**2010 Groundwater
Monitoring Report
Central Nevada Test Area,
Corrective Action Unit 443**

February 2011

NDEP Correspondence with Record of Review and Response to Comments

RE: Draft 2010 Groundwater Monitoring Report for the Central Nevada Test Area, Corrective Action Unit 443, January 2011
Federal Facility Agreement and Consent Order

Figure 4. Water Level Elevations in Reentry Well UC-1-P-2SR
(http://nevada.usgs.gov/doi_nv/sitepage_temp.cfm?site_id=383806116125951)

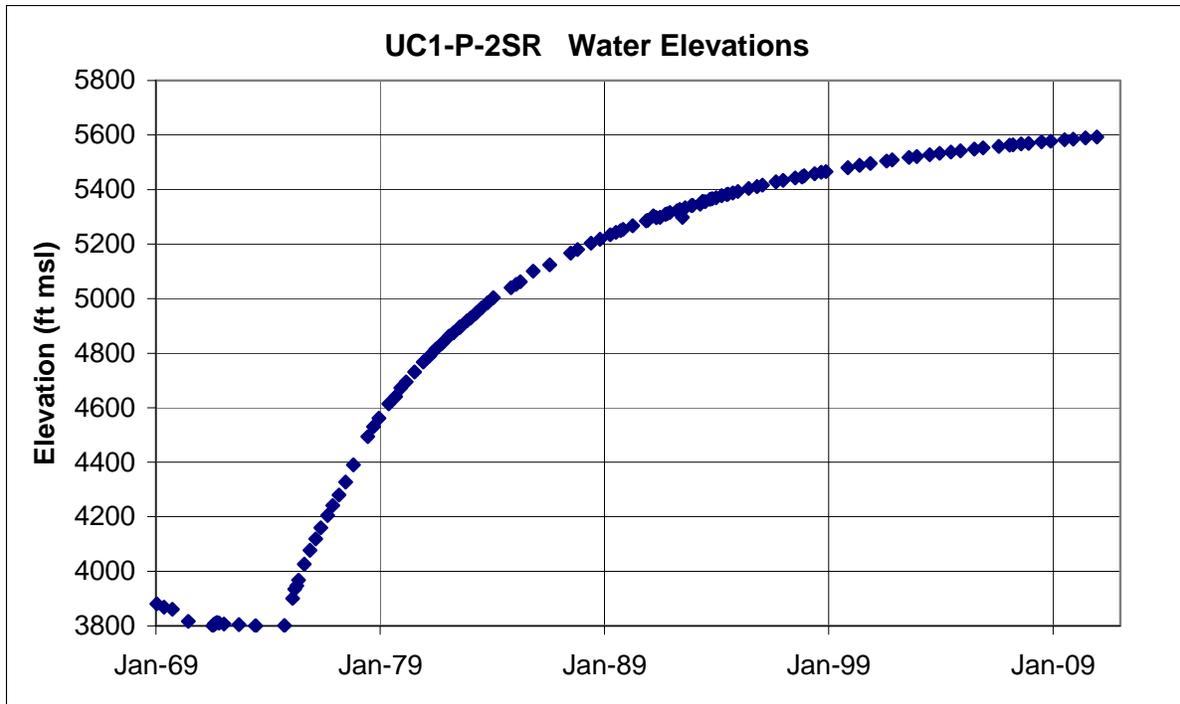
1. Page 7, Figure 4: There is no data from 2010 on this Figure although the text in the second paragraph of Section 3.0 states the water level in this well increased about 8 feet in 2010. Please correct the figure.

Item No.	Reviewer's Comments and Recommendation	Reqd. (Y/N)	Item No.	Author's Response (if required)
1	Page 7, Figure 4: There is no data from 2010 on this Figure although the text in the second paragraph of Section 3.0 states the water level in this well increased about 8 feet in 2010. Please correct the figure.	Y	1	The change was made as requested.
2	Page 8, Table 1: The 2010 data for Well UC-1-P-2SR should be added to this Table.	Y	2	The change was made as requested.
3	Page 11, Figure 6: The legend has UC-1-P-1s when it should be UC-1-P-1S. In addition, there is an arrow indicating the section of the plot before recompletion of this well. It would aid the reader to put an arrow toward the portion of the plot that is after recompletion and label it UC-1-P-1SRC as indicated in the text.	Y	3	The change was made as requested.
4	Page 12, Figure 8: The legend has UC1-P-2sr when it should be UC-1-P-2SR to be consistent with the Figure caption.	Y	4	The change was made as requested.

Figure 6. Water Level Elevations for the Alluvial Wells Northwest of the Southeast-Bounding Graben Fault

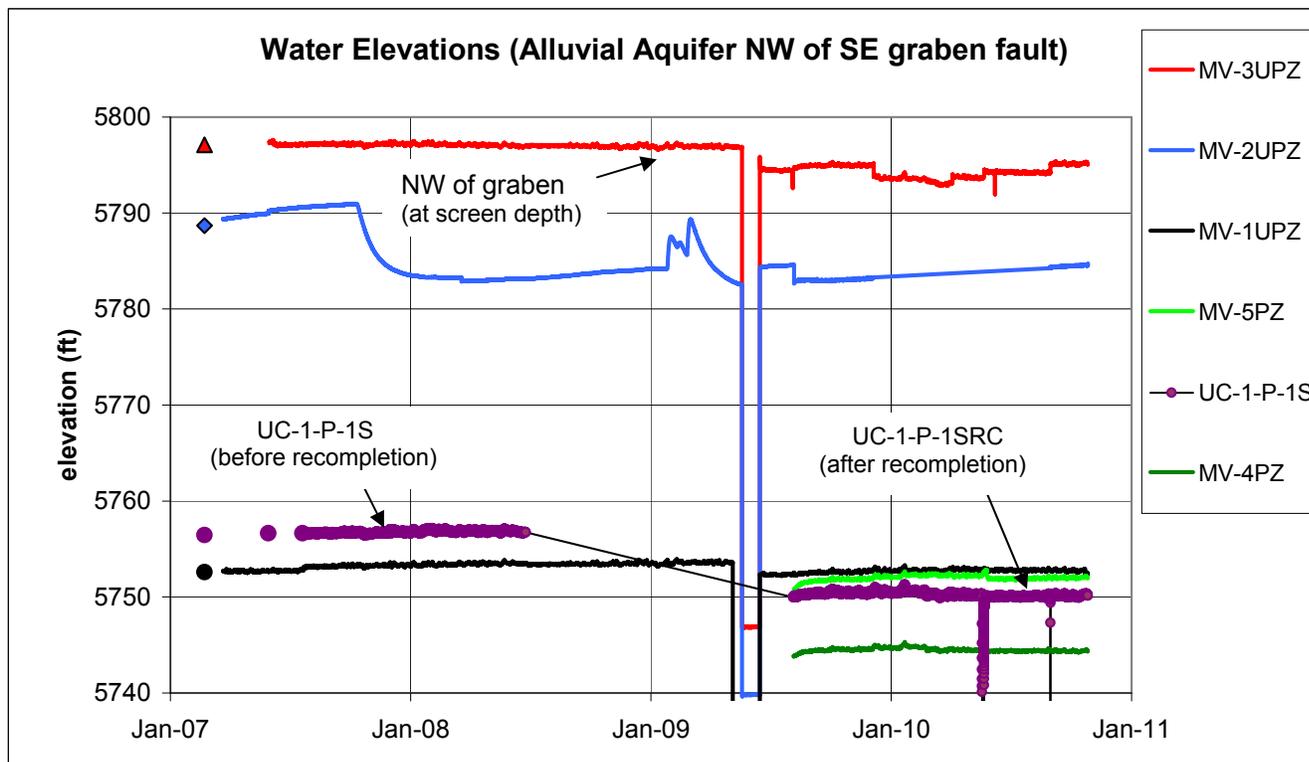
2. Page 8, Table 1: The 2010 data for Well UC-1-P-2SR should be added to this Table.
3. Page 11, Figure 6: The legend has UC-1-P-1s when it should be UC-1-P-1S. In addition, there is an arrow indicating the section of the plot before recompletion of this well. It would aid the reader to put an arrow toward the portion of the plot that is after recompletion and label it UC-1-P-1SRC as indicated in the text.

Figure 8. Water Level Elevations for the Wells Screened in the Volcanic Section Below the Level of the Detonation
 Water level elevations for re-entry well UC-1-P-2SR (drilled into the chimney) are shown for reference.

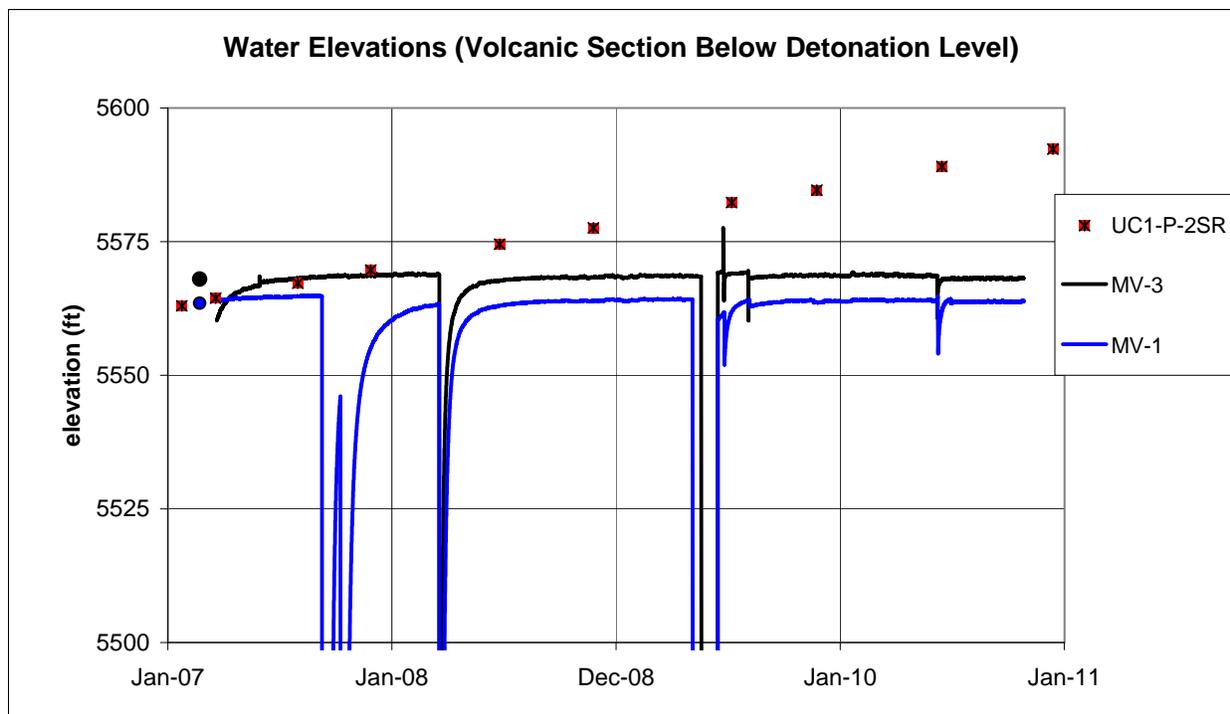
4. Page 12, Figure 8: The legend has UC1-P-2sr when it should be UC-1-P-2SR to be consistent with the Figure caption.
5. Page 13, Section 5.2, First Paragraph, Second Sentence: "The...MV-4 and MV-5 piezometers...." should be changed to "The...MV-4PZ and MV-5PZ..." to aid the reader in locating in the Table and Figures the appropriate head data under discussion.

Figure 9. Potentiometric Map for the Upper Part of the Alluvial Aquifer, CNTA

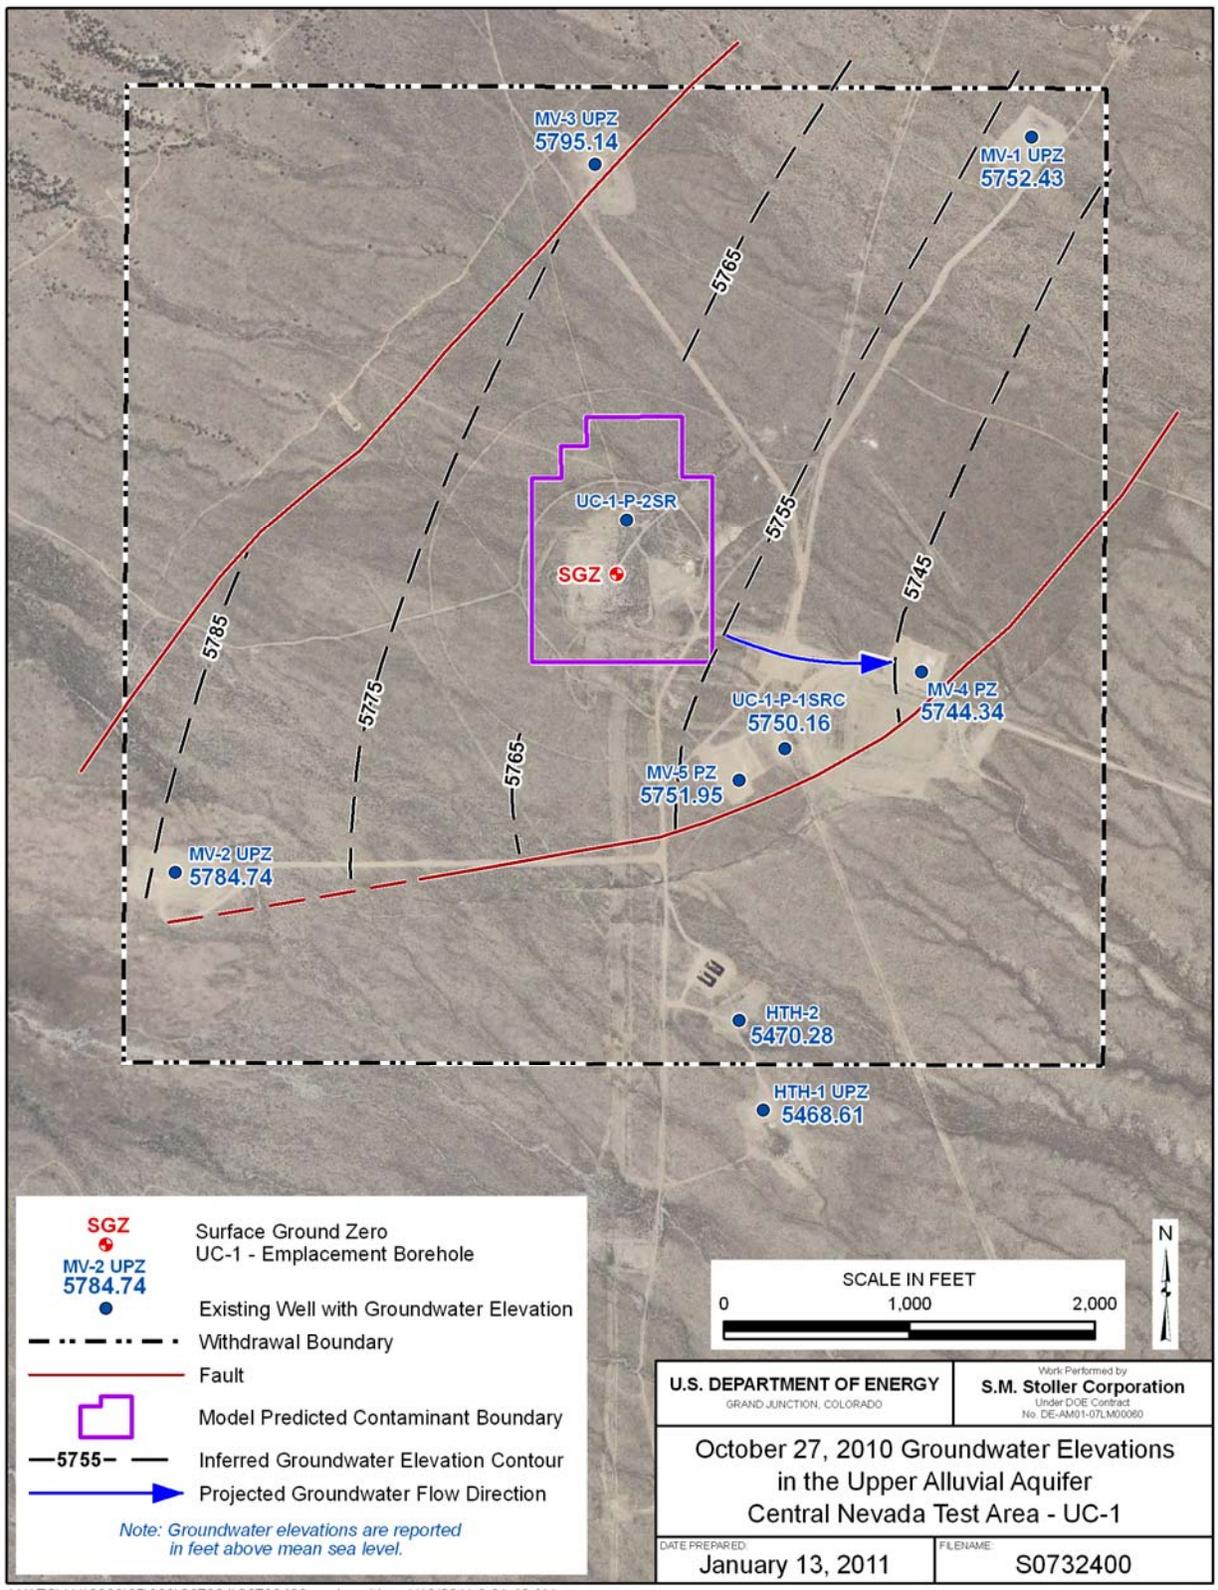
6. Pages 11 through 15, Section 5.2: It would be very helpful to have the text explaining each of the Figures immediately above or below the respective Figure, not two pages away. This change does not have to be done for the Final 2010 Report but should be made in the 2011 Report. This change will necessitate moving the current Figure 9 between the current Figures 6 and 7 and renumbering these three Figures.

Review No.	Project			
Item No.	Reviewer's Comments and Recommendation	Reqd. (Y/N)	Item No.	Author's Response (if required)
5	Page 13, Section 5.2, First Paragraph, Second Sentence: "The...MV-4 and MV-5 piezometers..." should be changed to "The...MV-4PZ and MV-5PZ..." to aid the reader in locating in the Table and Figures the appropriate head data under discussion.	Y	5	The change was made as requested.
6	Pages 11 through 15, Section 5.2: It would be very helpful to have the text explaining each of the Figures immediately above or below the respective Figure, not two pages away. This change does not have to be done for the Final 2010 Report but should be made in the 2011 Report. This change will necessitate moving the current Figure 9 between the current Figures 6 and 7 and renumbering these three Figures.	N	6	The change was made as requested.
